Proposed Development of
Crudine Ridge Wind Farm

**Response to Submissions
and Preferred Project Report**

November 2013

Prepared for Crudine Ridge Wind Farm Pty Ltd by Wind Prospect CWP Pty Ltd

Figure 6.1 Proposed over-dimensional vehicle route options for Project construction

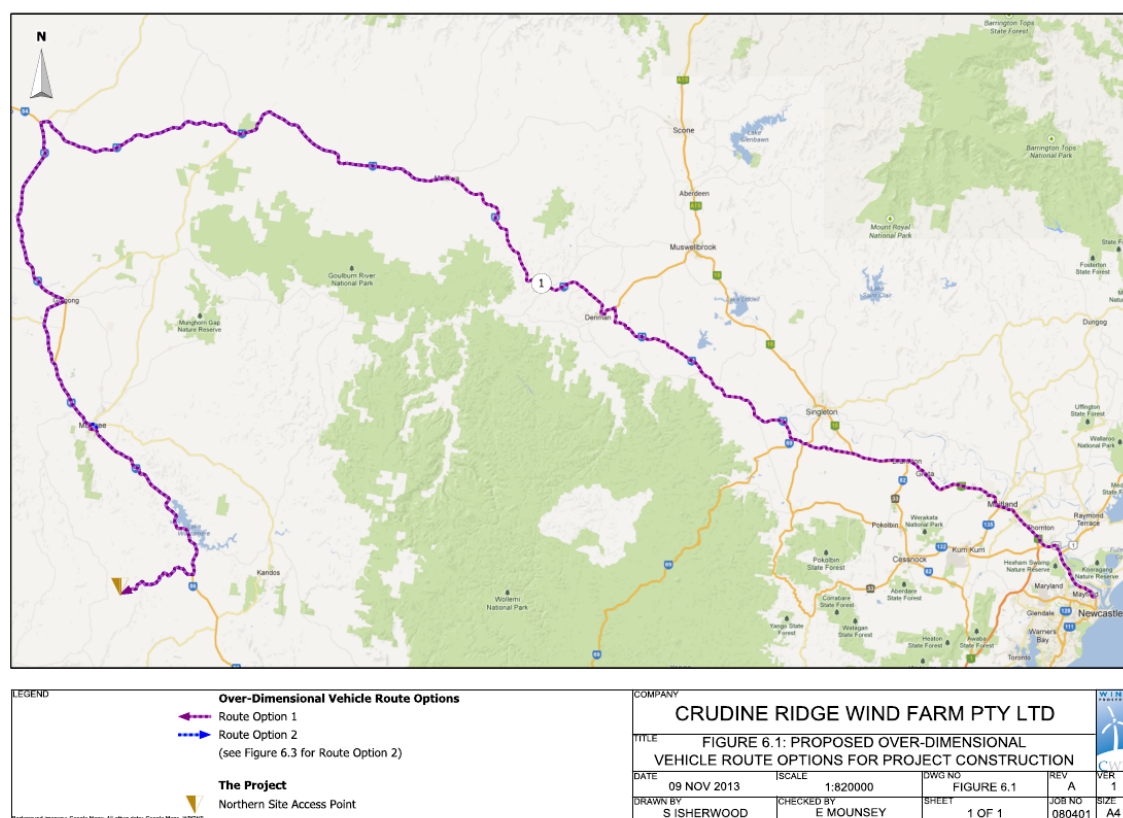
3.12.2 *RMS* **The preferred northern route will access the wind farm site from the Castlereagh Highway and then following Hill End Road, Windeyer Road, Pyramul Road and Aarons Pass Road. This preferred route requires a number of bridges to be assessed to determine if the bridges are able to accommodate projected over-mass and over-size vehicle movements. Should a number of the bridges be found to be unsuitable, it is assumed that other routes will be considered. Should this occur, RMS would request an opportunity to review and comment on the alternative route(s) proposed.**

Response: Noted. Transport access routes have been revised and re-assessed in response to feedback (see Section 6 PPR). If bridges along the route are unsuitable, appropriate (temporary or permanent) upgrades will be undertaken. Dilapidation surveys of transport routes will be undertaken prior to construction in order to document existing conditions with a view to repairing any damage resulting from construction traffic, except that resulting from normal wear and tear, as per Statement of Commitment 024.

The preferred transport route extends from Newcastle to the northern site access point, passing through the Mudgee urban area and utilising APR (Route Option 1, Figure 6.1). An additional, alternative route through the Mudgee urban area is proposed for over-length vehicles only (Route Option 2, Figure 6.3).
